Addendum No. 02

RFQ-ES-2024-1

Title: Supply & install four (4) VHF analog/digital radio repeaters for Kincardine Fire and Emergency Services

Figure 2 Tiverton location

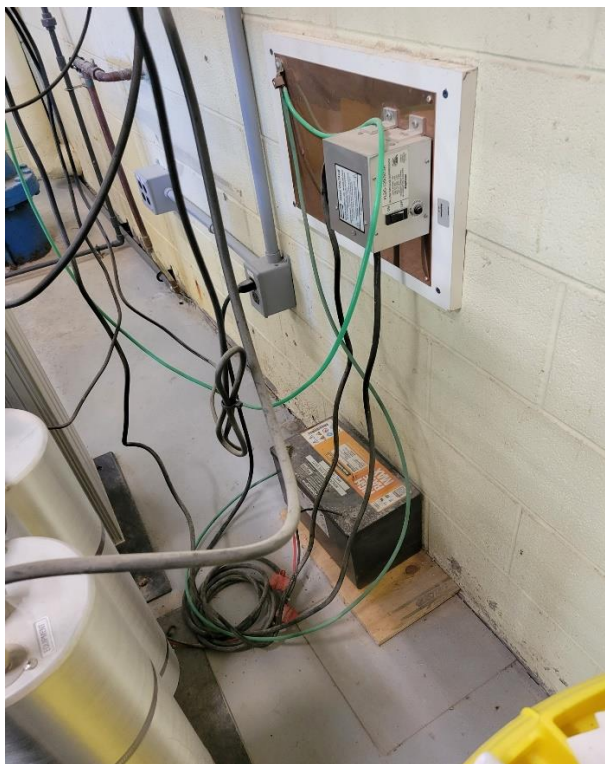
Question #4: Can you share photos of the sites?

Answer #4:
